Access Compliance Report

Public Rights-of-Way (Curb Ramps)

Intersection ID: 20874	Main Street: STEELE_CREEK_RD	Cross Street: WESTINGHOUSE_COMMONS_DR	Location: NW
ADA ID: 0C57CA018166	Ramp Type: Directional1	Initial Pass/Fail: Fail	Overall Compliance: No
		Severity Score: 1.25

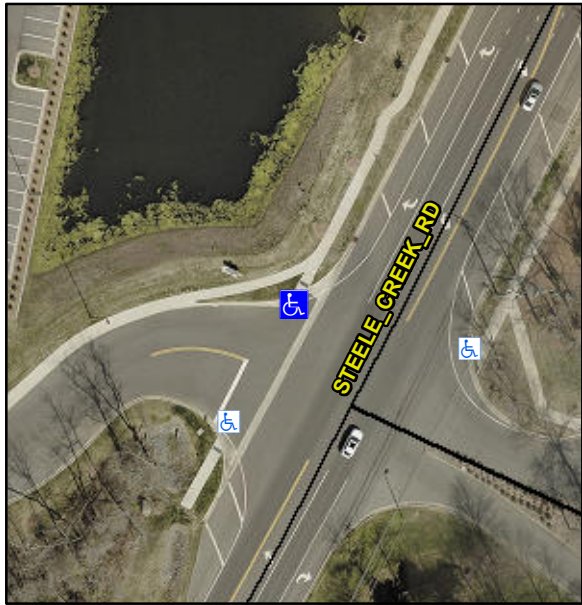
Codes/Mitigation Info/Possible Solution			Field Measurements/Component Compliance					
	Possible Solutions:		Compliance	Description	Data	Compliance	Description	Data
	Remove & Replace Entire Ramp.		N/A	Ramp Length (in)	80.0	N/A	Grade Break?	N/A
			Yes	Ramp Width (in)	60.0	N/A	Grade Break Slope (%)	0.0
			Yes	Ramp Slope (%)	3.1	N/A	Grade Break XSlope (%)	0.0
			No	Ramp XSlope (%)	4.1			
			N/A	Flare Type LT	N/A	N/A	Flare Type RT	N/A
			N/A	Flare Slope LT (%)	N/A	N/A	Flare Slope RT (%)	0.0
			N/A	Flare Traversable LT?	N/A	N/A	Flare Traversable RT?	N/A
	Surveyor Notes:		N/A	Landing Length (in)	0.0	N/A	DWS Provided?	N/A
	N/A		N/A	Landing Width (in)	0.0	N/A	DWS Contrast?	N/A
		N/A	Landing Slope (%)	0.0	N/A	DWS Length (in)	N/A	
		N/A	Landing X Slope (%)	0.0	N/A	DWS Full Width?	N/A	
PROW/ADA:		N/A	Landing Curb? (Y/N)	N/A	N/A	DWS Offset LT (in)	N/A	
R304.5.3		N/A	Shared Landing?	N/A	N/A	DWS Offset RT (in)	N/A	
		N/A	Gutter Ponding?	0.0	N/A	Gutter Slope (%)	N/A

N/A	Gutter Lip Ht (in)	0.0	N/A	Gutter X Slope (%)	N/A	
		N/A	Painted X Walk1?	No		Road Slope (%)	1.2	
			X Walk 1 Direction	To SW		Road X Slope (%)	2.8	
			X Walk 1 Width (in)	N/A		Clear Space?	N/A	
			X Walk 1 Slope (%)	1.2	N/A	Clear Space to XWalk (in)	N/A	
			X Walk 1 X Slope (%)	2.8	N/A	Storm Grate/Utility Hazard?	N/A	
		N/A	Ramp inside XWalk1?	N/A		Storm Grate/Utility Type		
		N/A	Any Obstructions?	N/A			N/A	
			Obstruction Type		Yes	Surface Condition? (G/P)	Good	
					N/A	Curb Slope (%)	2.0	
Total Cost:		\$ 1600.00						
Street 1 Name		ENTRANCE						
Stop Condition-Street 1		StopSign						
Street 2 Name		N/A						
Stop Condition-Street 2		N/A
